10. *The Park Advisory Board recommends that the Planning Commission and the Board of County Commissioners include the following conditions when considering and/or approving the Paint Brush Hills Filing No. 14 Final Plat: (1) Provide to El Paso County a 25-foot trail easement along the northern boundary of Paint Brush Hills Filing No. 14 Final Plat, within Tract A, that allows for the construction, maintenance, and public access of the Arroya Lane Primary Regional Trail, and dedicate the aforementioned easement to El Paso County prior to the recording of the Final Plat; (2) The developer will relocate the proposed storm facility from Tact A to allow the trail to be constructed on the trail easement or provide the trail easement through lots 24-30.*

STREET IMPROVEMENT PLANS

PAINT BRUSH HILLS FILING NO. 14

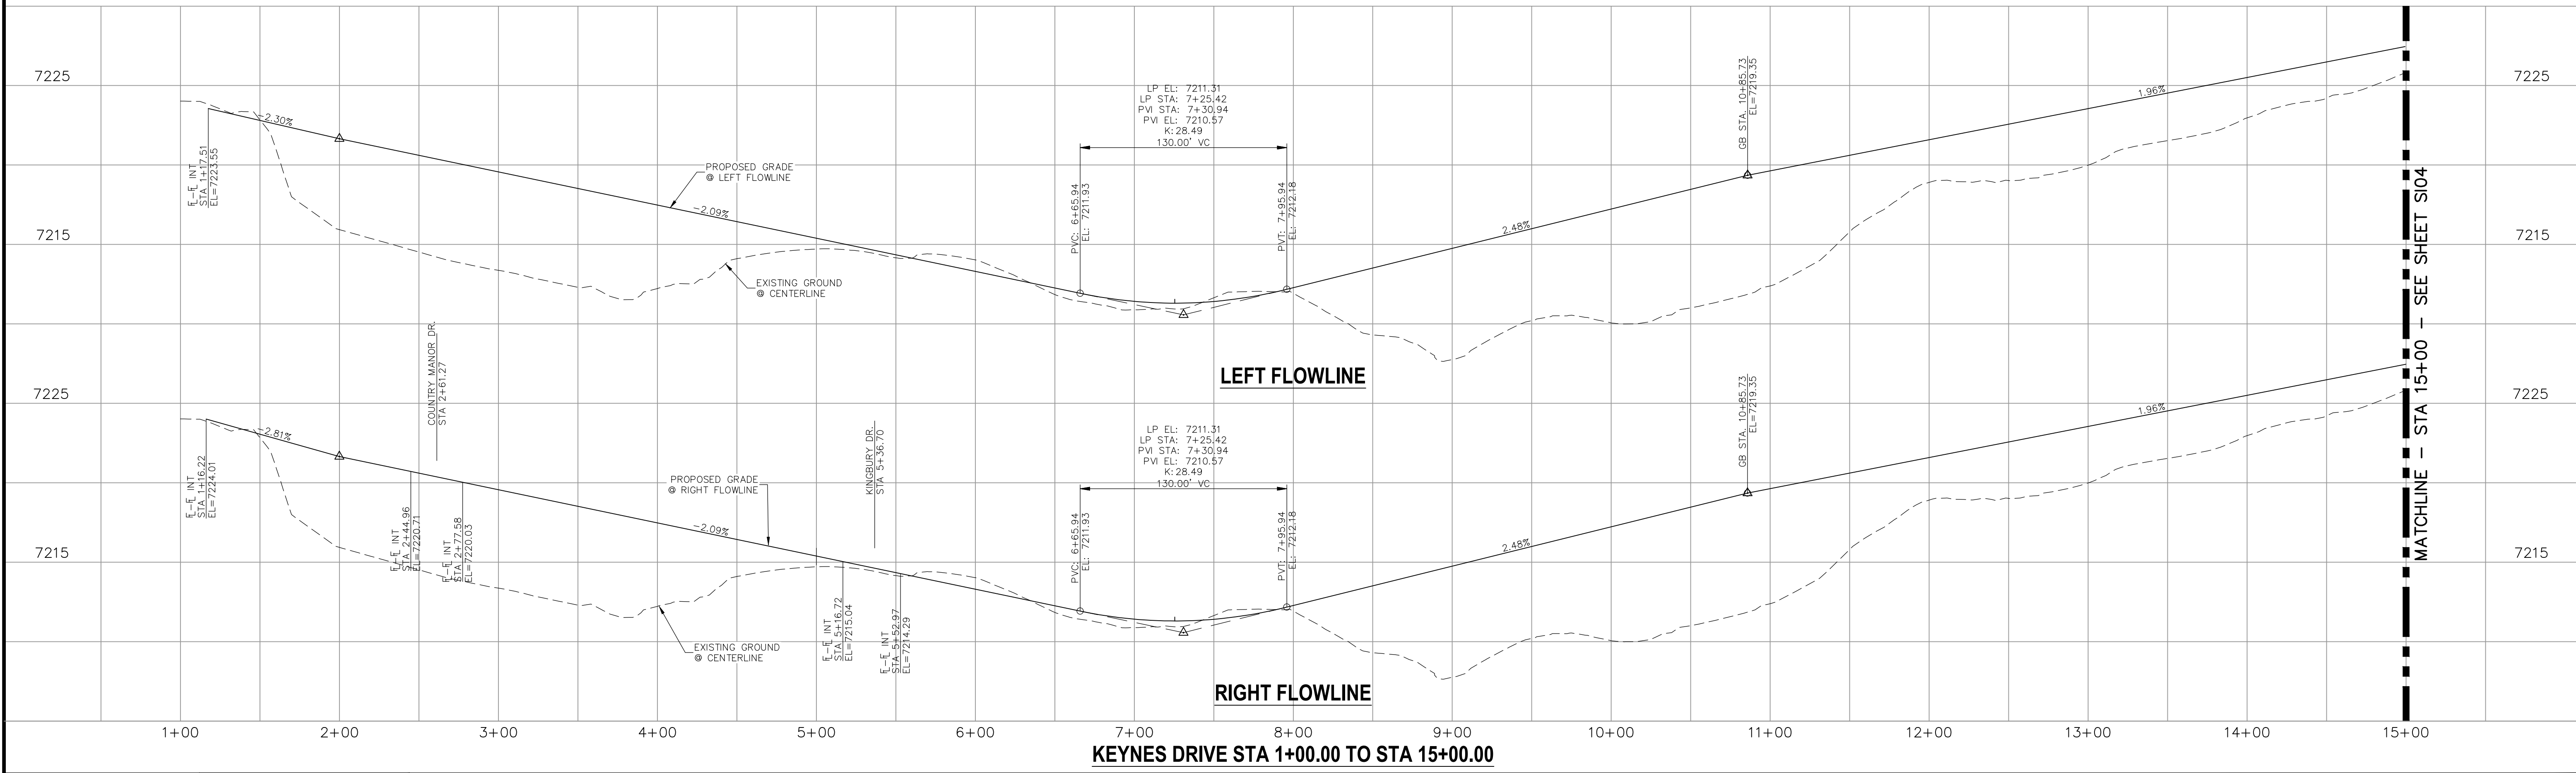
Detail moved to S102, very clarify

S11

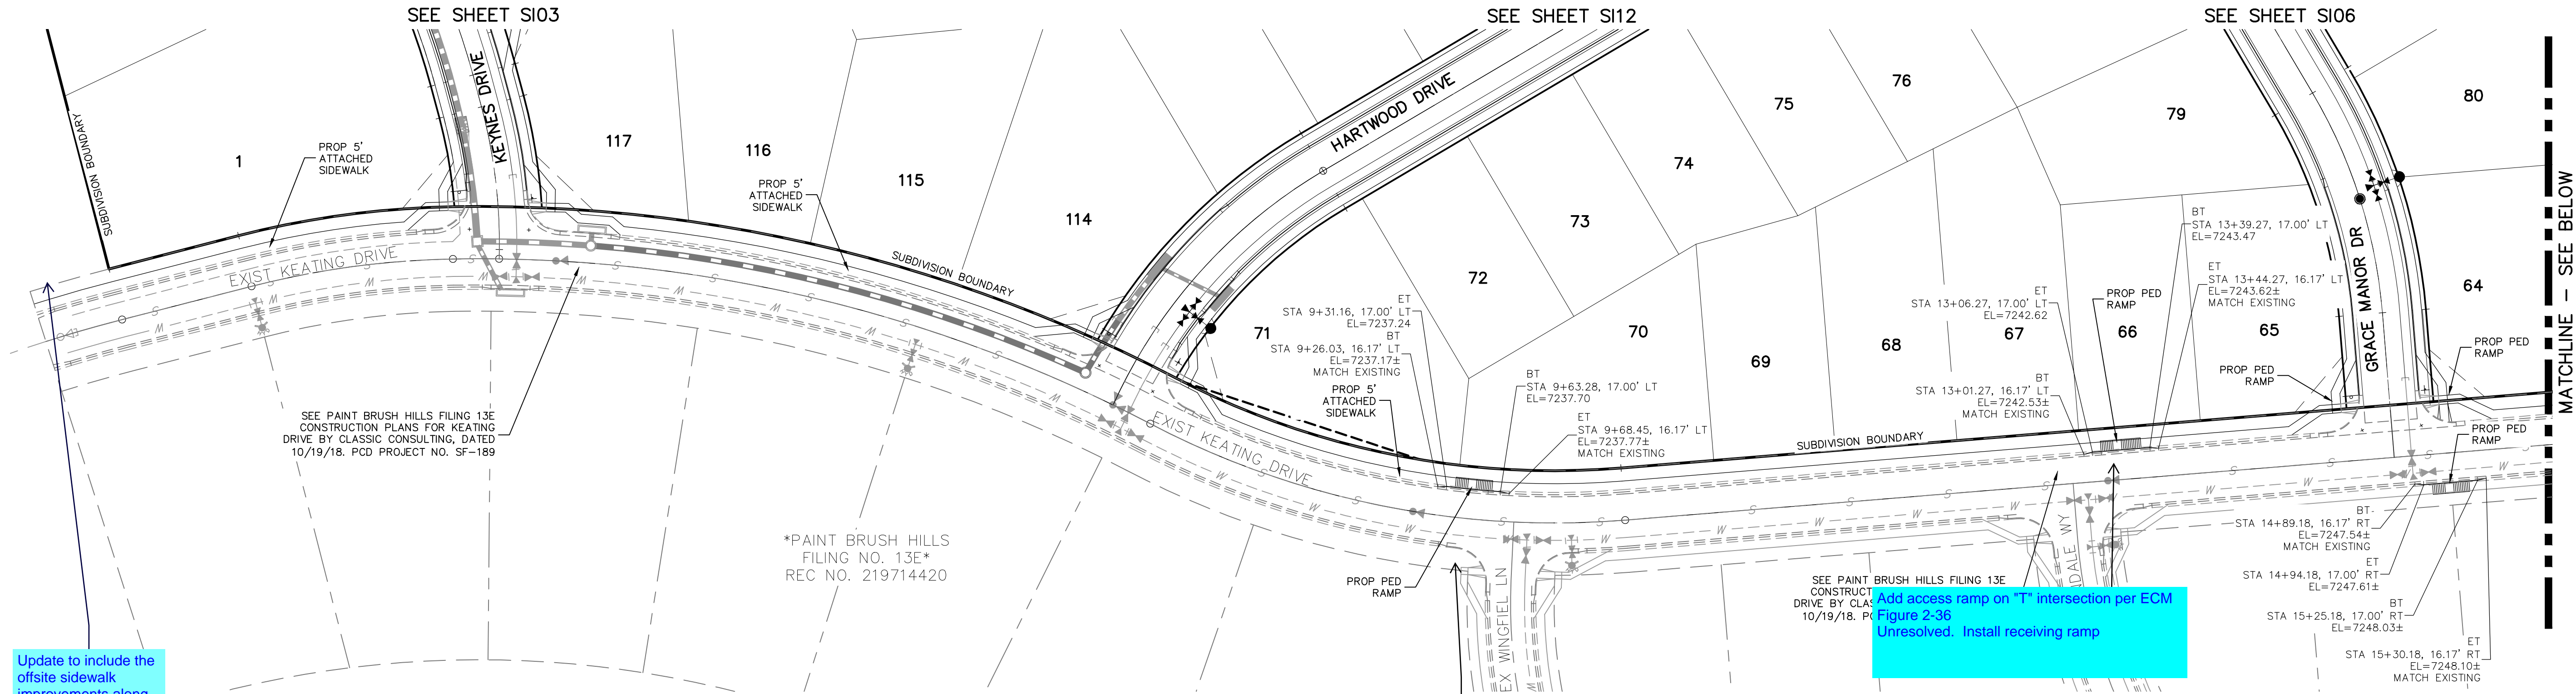
Update to include the offsite sidewalk improvements along Keating Dr and Rockingham

Add access ramp on Tⁿ intersection per ECM Figure 2-36
Unresolved. Install receiving ramp

Added as requested

Added as requested

KEYNES DRIVE & COUNTRY MANOR DRIVE

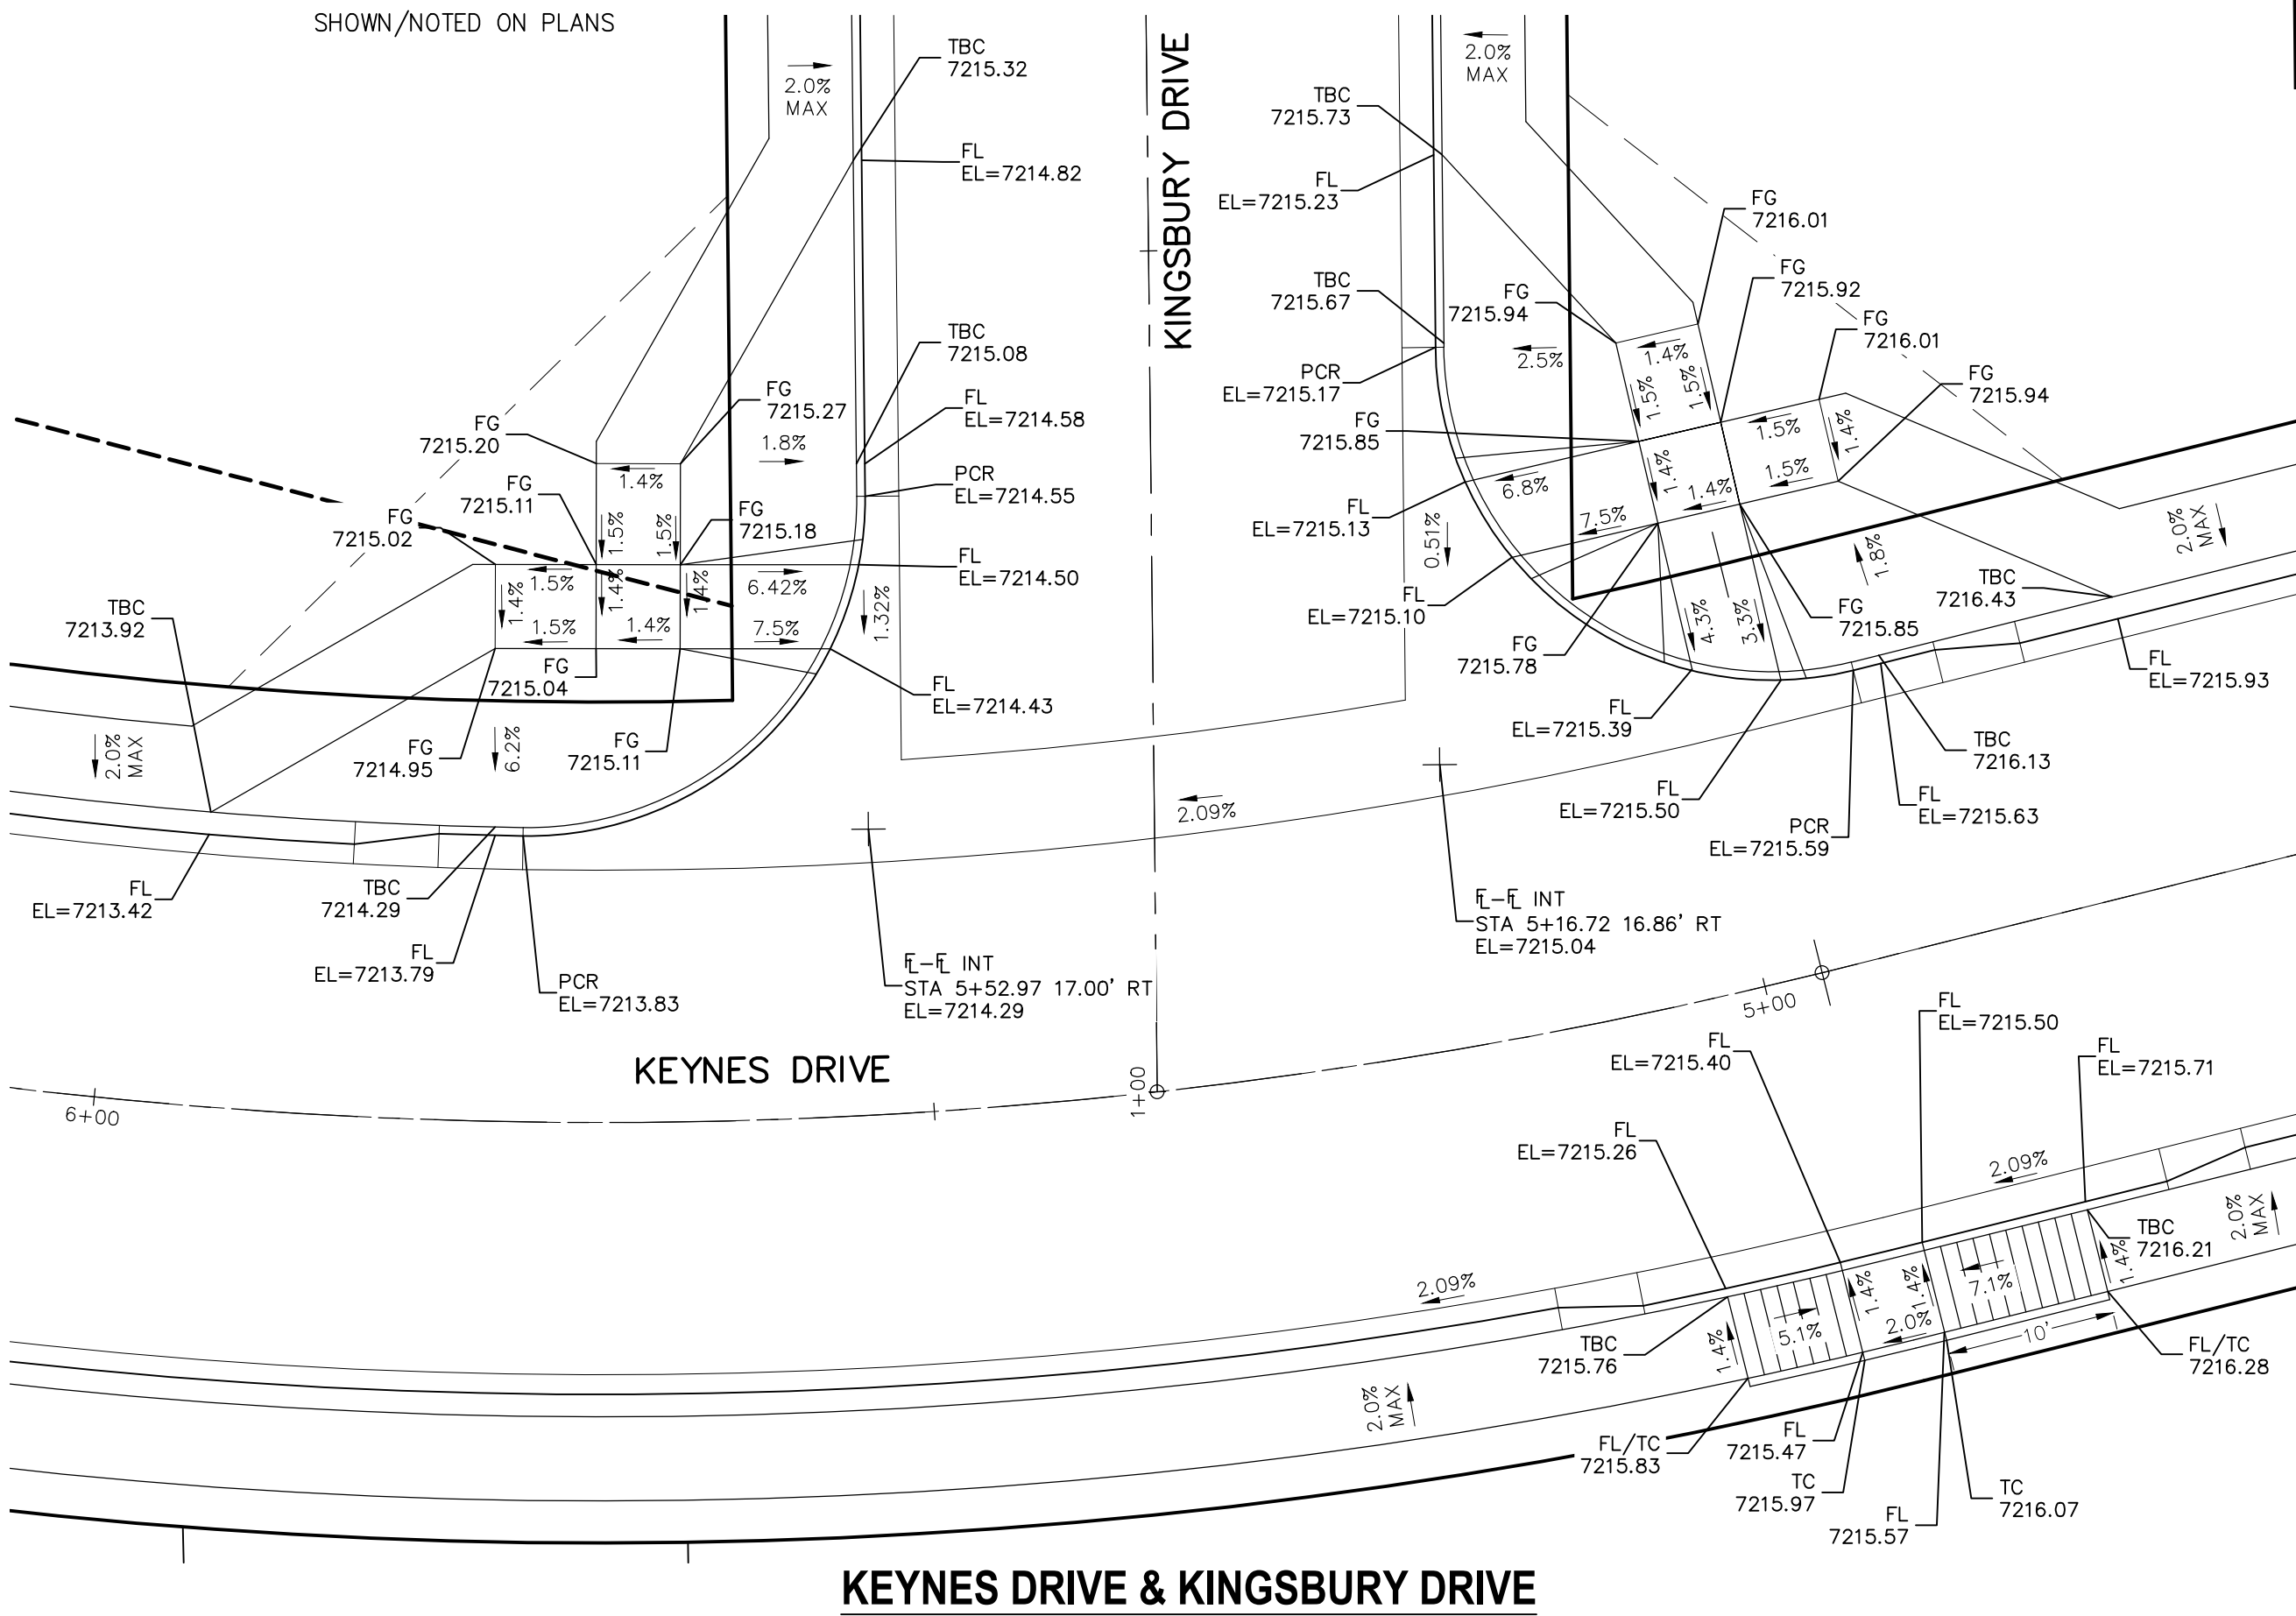
provide slope. Typical comment for all intersection details.

If the PAR exceeds 5% then these are considered ramp run and landings are required on both ends with edge protection. See ECM 6.3.1.G.5, ECM 6.3.1.G.6, and Figure 6-8 for criteria.

Comment applies to all intersection details and will be reviewed on the resubmittal once the request information is shown.

See ECM 6.3.2.C and Figure 6-9 for criteria.

Comment applies to all intersection details and will be reviewed on the resubmittal once the request information is shown.
